SUBJECT: Grand Gulf Nuclear Station
Units 1 and 2
Docket Nos. 50-416 and 50-417
File 0260/0277/L-860.0/L-814.1
NUREG-0588 Evaluation - Response
to NRC Trip Report of
January 18, 1982
AECM-82/141

The purpose of this letter is to provide MP&L's response to the NRC Equipment Qualification Branch Trip Report - Audit of Documentation Concerning Environmental Qualification of Electrical Equipment for Grand Gulf Unit 1.

Figure 1

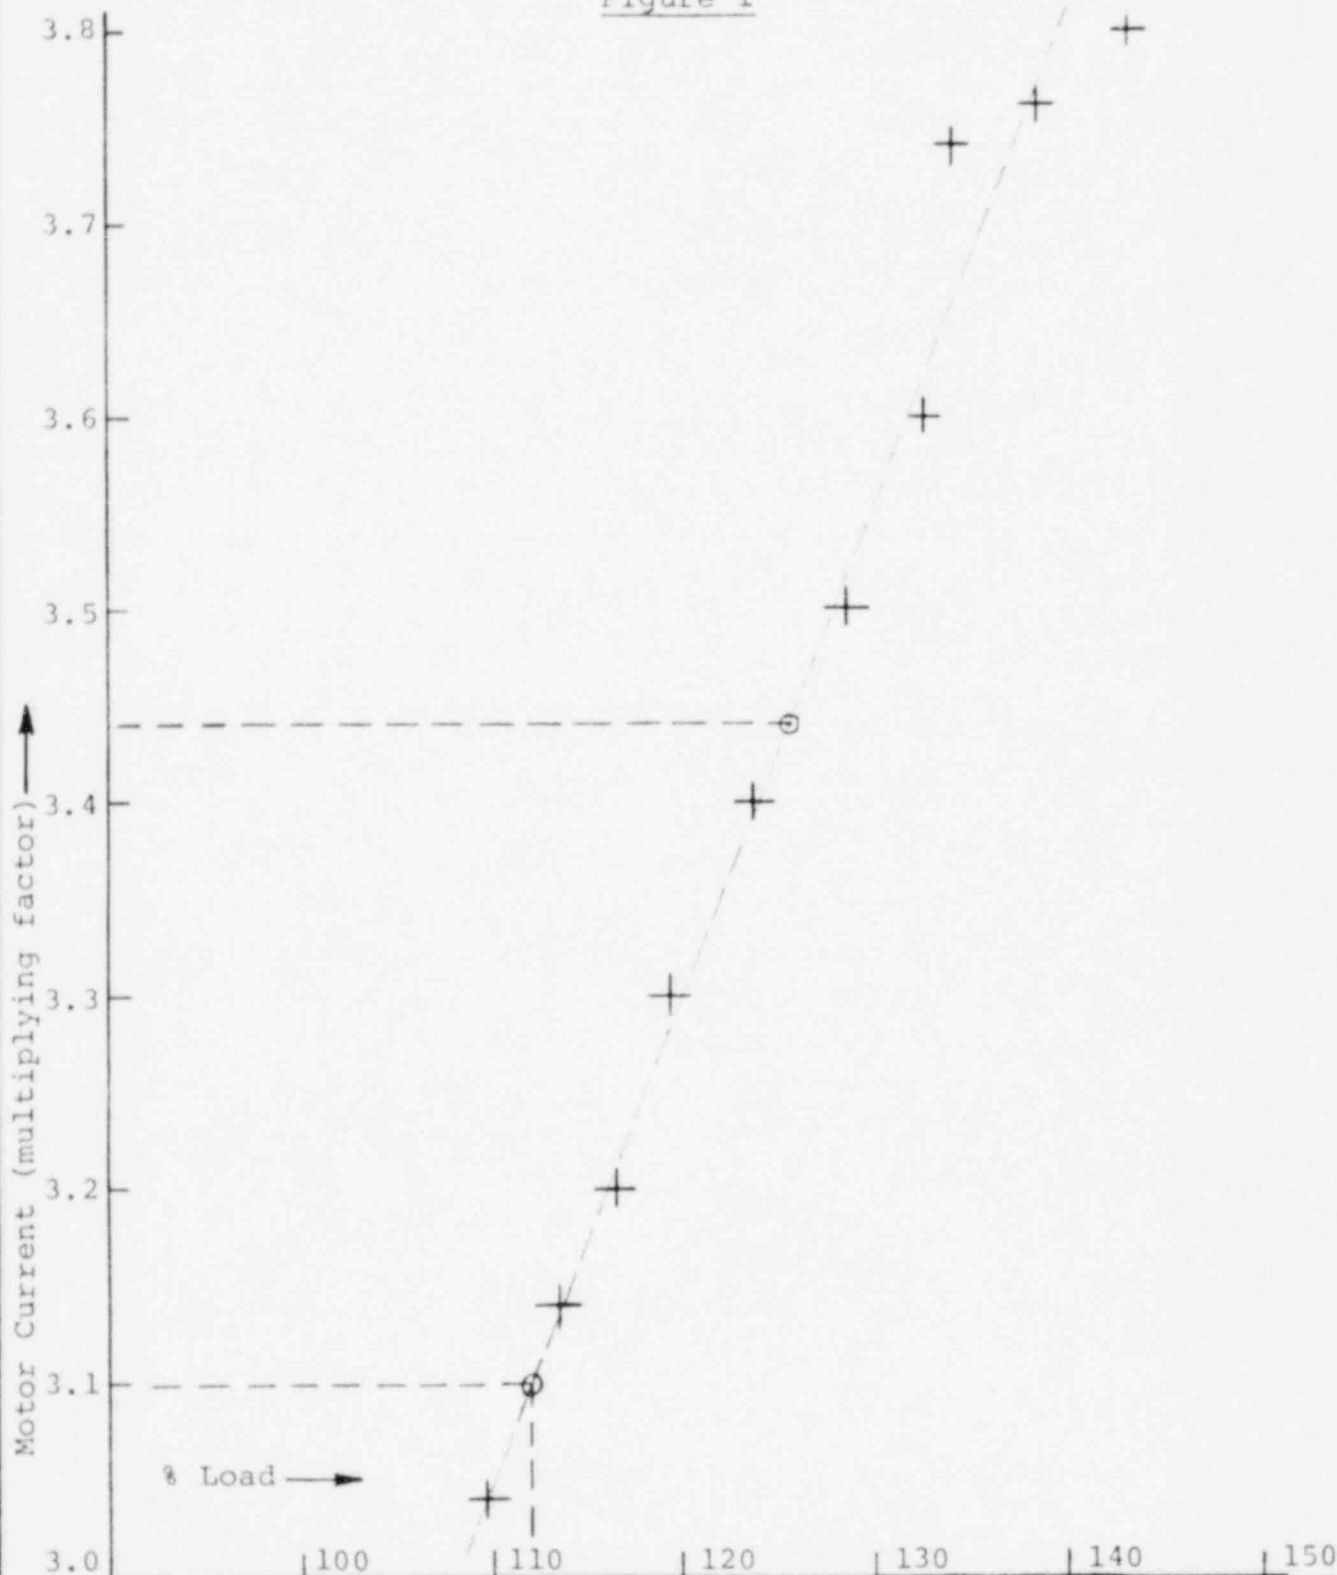
The above data is plotted as Amps vs. % rated load in Figure 1

From Figure 1, by interpolating test data the motor current at 112% rated load is obtained as 3.1I...(1)

This shows, the motor current will increase by 24% of the rating for 112% rated load and 90% rated voltage. This current is equivalent to 3.44I of the plot in Figure 1 (3.44I corresponds to 126% of the rated load).

- i) Winding temperature rise is proportional to Ohmic heating (I^2R), the source of motor winding heating.
- ii) Motor current will increase almost with the same proportionality till the load of 132% since it can be seen from Figure 1 that up to 132% of the rated load, the curve is almost a straight line.
- iii) The fan cooling rate at a given ambient will almost be the same since the speed of the induction motor does not change significantly with overload.
